CNRO-2002-00022

SUBJECT: Entergy Operations, Inc.
Response to NRC Request for Additional Information Regarding
Proposed Alternatives to ASME Requirements for Weld Repairs (TAC
Nos. MB4286, MB4288, and MB4289)

**RESPONSE TO NRC REQUEST FOR ADDITIONAL INFORMATION
PERTAINING TO REQUEST No. PWR-R&R-001, Rev. 0
(TAC Nos. MB4286, MB4288, and MB4289) DATED MARCH 28, 2002**

**RESPONSE TO NRC REQUEST FOR ADDITIONAL INFORMATION
PERTAINING TO REQUEST No. PWR-R&R-001, Rev. 0
(TAC Nos. MB4286, MB4288, and MB4289) DATED APRIL 18, 2002**

Partial Penetration J-Weld

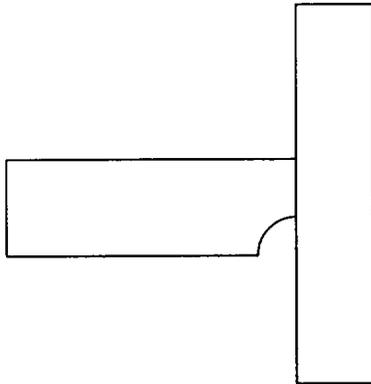
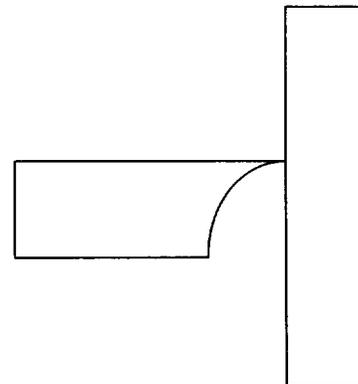
2. Assuming IWA-4530 applies, it has a limitation: "The repairs to a completed joint shall not exceed one-half the joint thickness. The surface of the completed repair shall not exceed 100 sq. in." From the descriptions of Figures 2 and 3 of the submittal dated March 29, 2002, the repairs could extend through-wall. Explain why Code limited repairs to one-half the joint thickness. What are the concerns with a through-wall temper bead repair?

Response to Item 2

Entergy has deleted temper bead repairs of RPV penetration nozzle base materials from PWR-R&R-001 to clarify that it only applies to ambient temperature temper bead weld repairs of the J-weld. Entergy is not proposing a through-wall repair. Although the proposed weld repair may be a full throat or full depth repair of the partial penetration J-weld, it is not through-wall as explained below.

ASME Section IX, Welding and Brazing Qualifications, defines the terms "joint" and "joint penetration" as follows: [Identical or equivalent definitions are provided in American Welding Society's (AWS) standard ANSI/AWS A3.0-89, Standard Welding Terms and Definitions.]

- *Joint - The junction of members or the edges of members which are to be joined or have been joined.*
- *Joint Penetration – The minimum depth a groove weld extends from its face into a joint, exclusive of reinforcement.*

A "joint" is the junction of members to be welded irrespective of weld type (i.e. single bevel groove, double V-groove, J-groove, etc.) or depth of weld penetration (i.e. partial penetration or full penetration) in the joint. "Joint penetration" defines the depth of weld penetration in a joint. Full penetration welds penetrate the full length or depth of the adjoining members in a joint. Partial penetration welds only partially penetrate through the joint such that part of the joint remains unwelded. Examples of partial and full penetration J-welds in a "T-Joint" are shown below.

The "joint" between the RPV head and each RPV penetration nozzle is best described as a T-Joint. The weld that attaches each RPV penetration nozzle to the RPV head is a partial penetration J-weld. Examples of partial penetration welds are shown in NB-4244(d)-1 of ASME Section III. The J-weld throat dimensions at ANO-1, ANO-2, and Waterford 3 are substantially less than one-half the joint thickness. Therefore, a full throat or full depth J-weld repair can be performed and not exceed the depth restriction of IWA-4330. See Response to Question 7 for additional information.

Typical RPV Head Penetration Nozzle

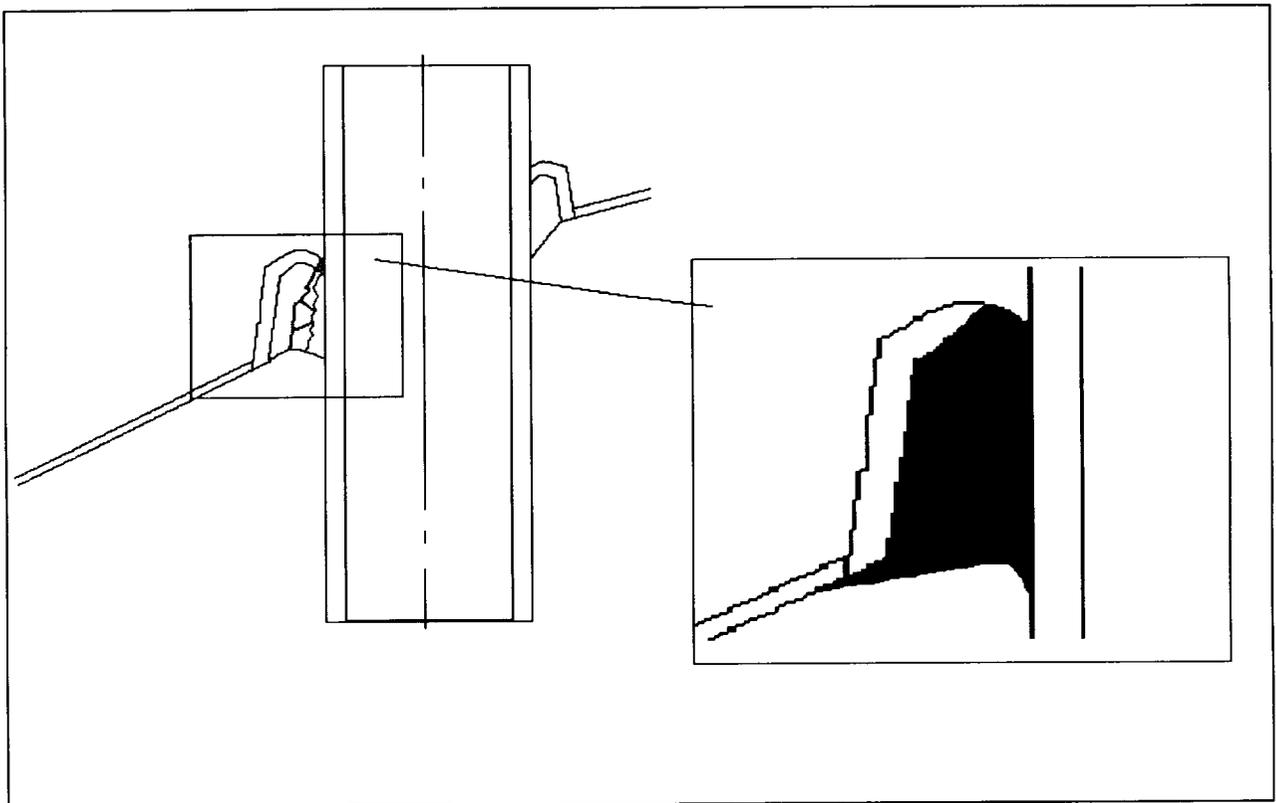
4. Please provide a discussion and cross-sectional sketch of the weld repair.

Entergy has provided sketches depicting a typical RPV head penetration nozzle (Figure 1) and an example repair of an RPV head penetration nozzle J-weld (Figure 2) in revised PWR-R&R-001.
